To All vendors: Addendum #1

Wood River Elementary Foundation & Plumbing Repair

This addendum serves as a Notice of Clarification of the Scope of Work intended.

SHEET NUMBER
8.2
 OF
 SET NO.

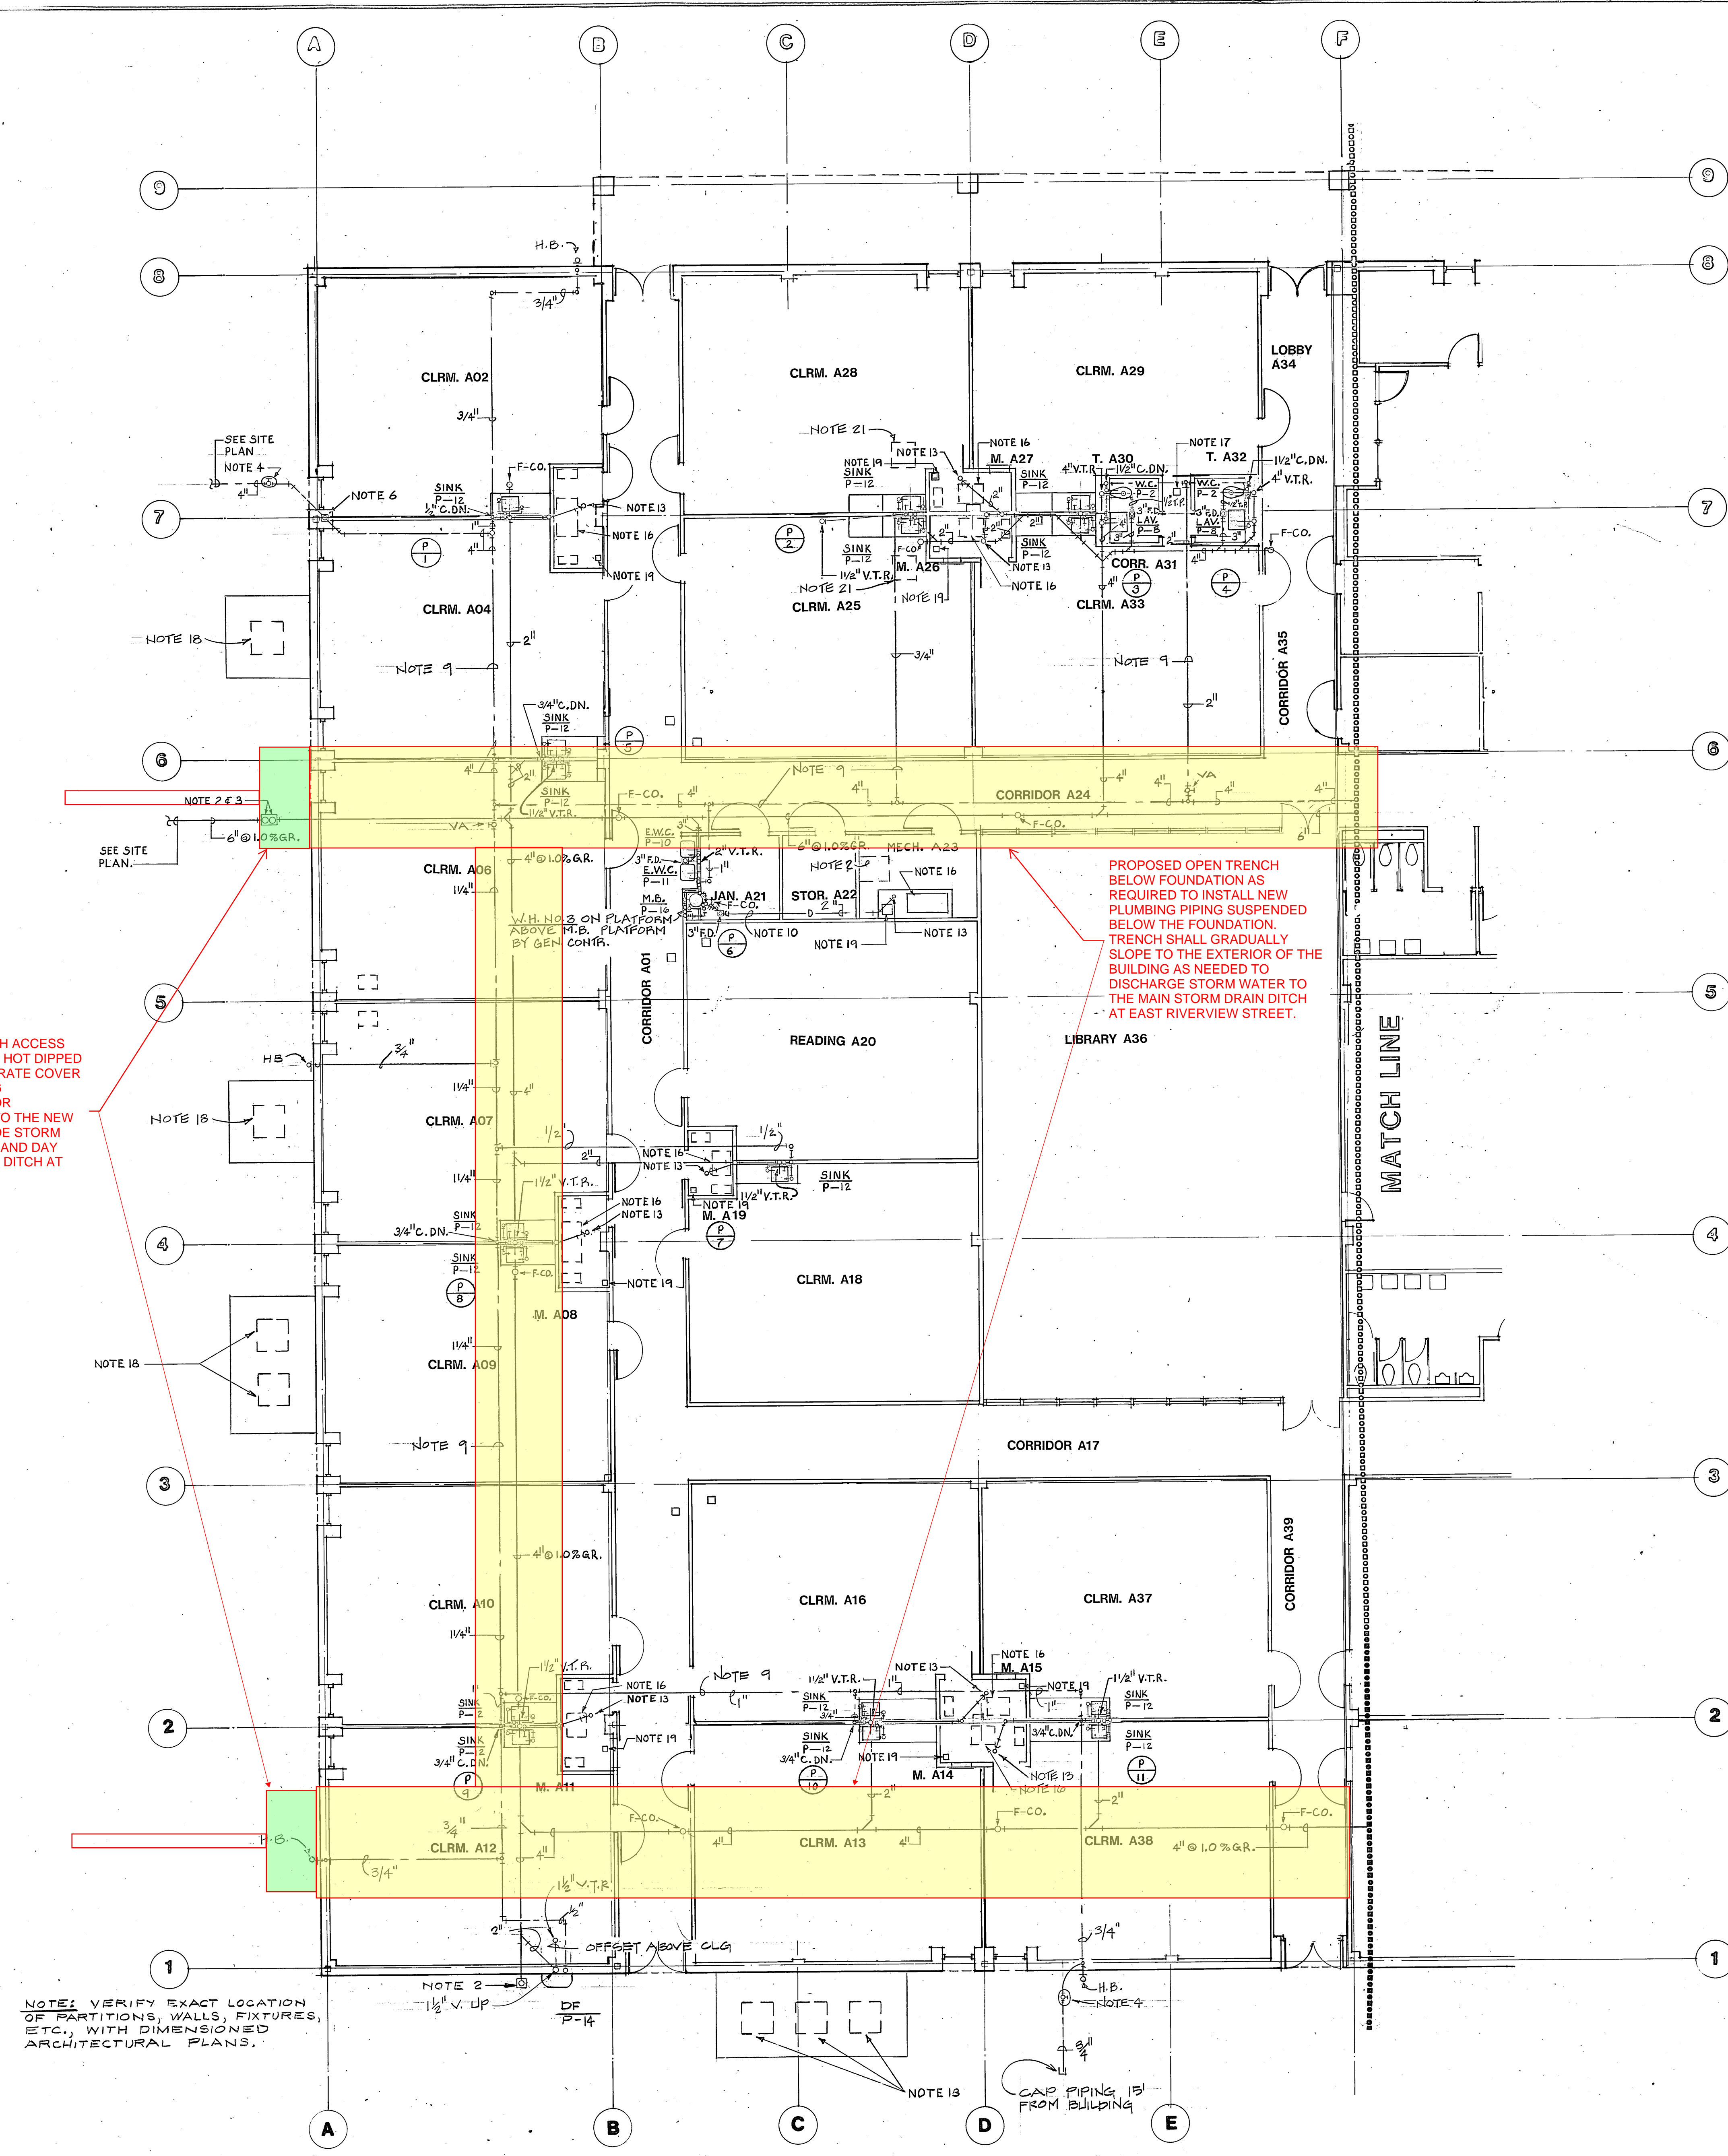
PROVIDE CONCRETE TRENCH ACCESS AND VENTILATION BOX WITH HOT DIPPED GALVANIZED STEEL OPEN GRATE COVER ATTACHED TO THE BUILDING FOUNDATION AS NEEDED FOR VENTILATION AND ACCESS TO THE NEW PLUMBING TRENCH. PROVIDE STORM DRAIN PIPE UNDERGROUND AND DAY LIGHT TO THE STORM DRAIN DITCH AT EAST RIVERVIEW STREET.

PROPOSED OPEN TRENCH BELOW FOUNDATION AS REQUIRED TO INSTALL NEW PLUMBING PIPING SUSPENDED BELOW THE FOUNDATION. TRENCH SHALL GRADUALLY SLOPE TO THE EXTERIOR OF THE BUILDING AS NEEDED TO DISCHARGE STORM WATER TO THE MAIN STORM DRAIN DITCH AT EAST RIVERVIEW STREET.

FLOOR PLAN-A
 SCALE 1/8" = 1'-0"
 TRUE NORTH PLAN NORTH

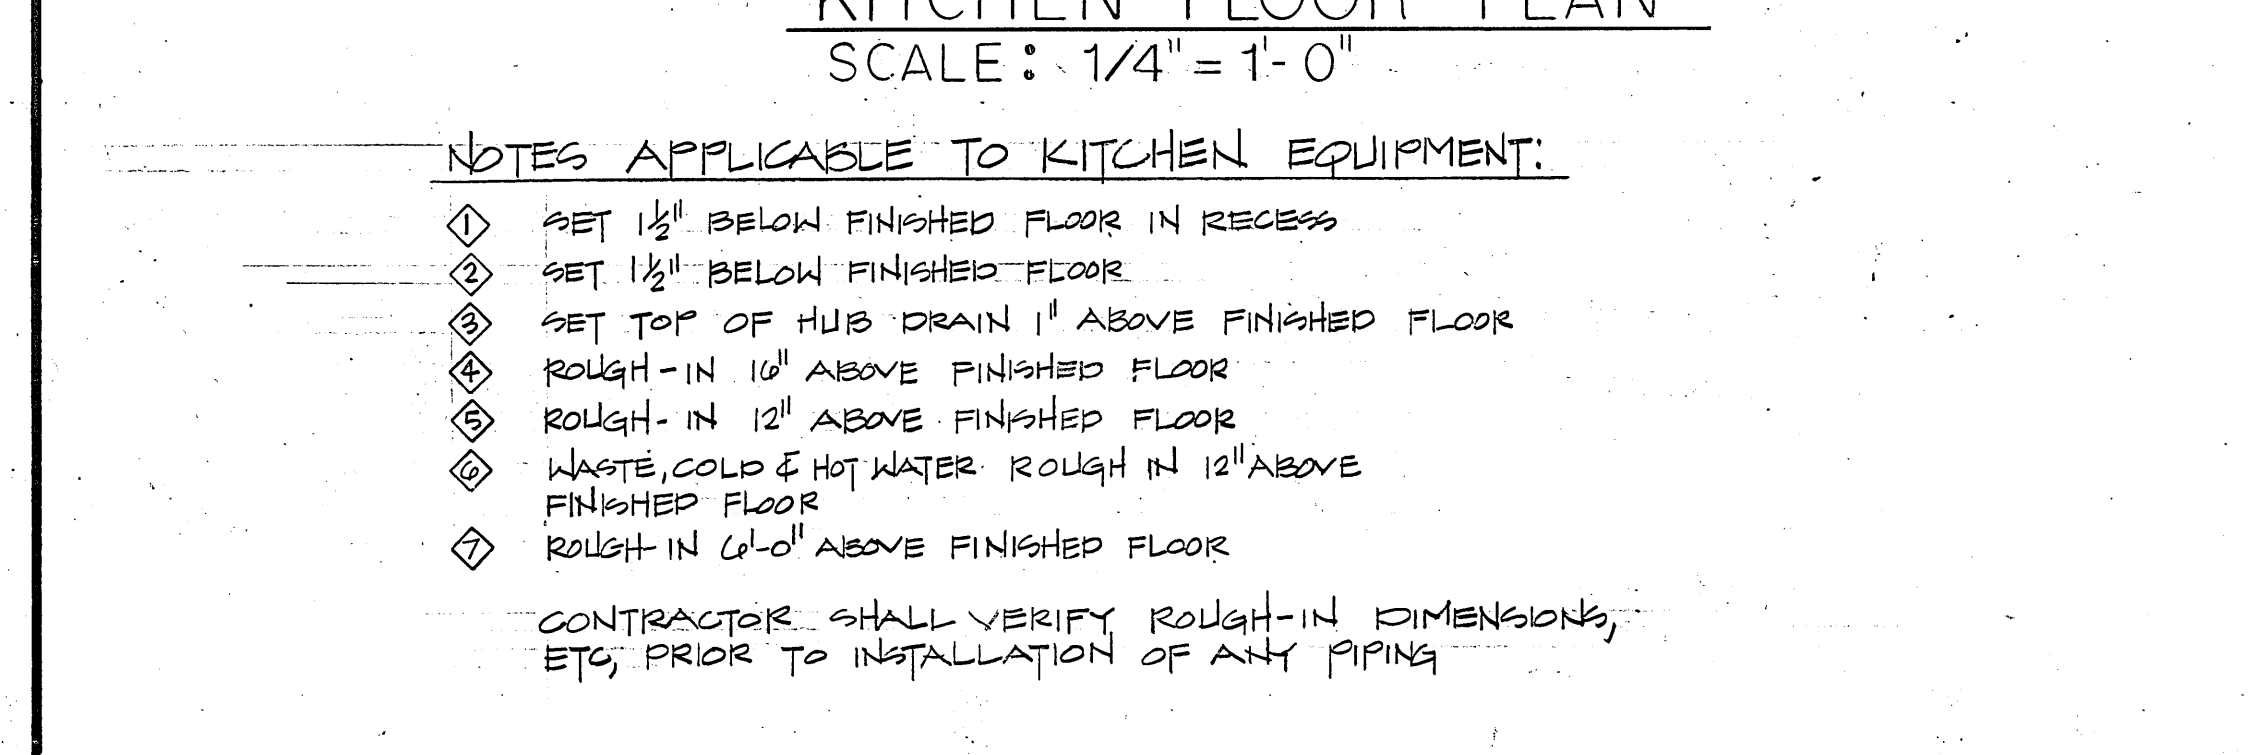
All water piping sizes remained same size.
Only change was re-route to accommodate A/C Duct.
Sanitary sewer in foundation adjusted to piers and columns.
